GTS Newsletter

2011/07E

Machine	TASKI swingo XP
Subassembly	Pad drive

Modification Pad drive

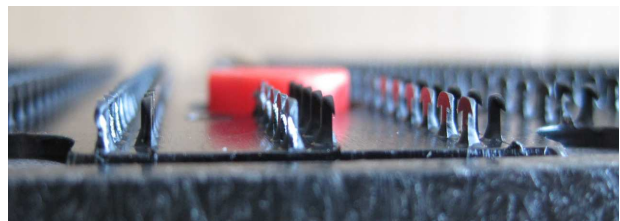
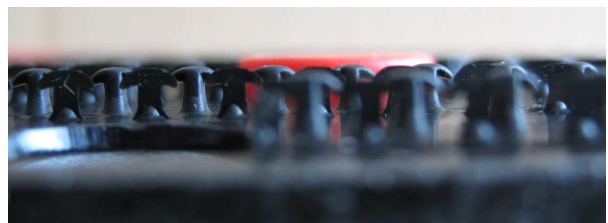
Internal tests have shown that the harpoon grip of the pad drive gets damaged as soon as the same is touching the ground without the pad. To avoid this small cams have been attached, which are protecting the harpoon grip and allowing a longer lifetime of the pad drive.

During each service we recommend to check the existing pad drives about contamination and damages. Contaminated pad drives can be cleaned with a steel brush. Damaged/worn out pad drives should be replaced.
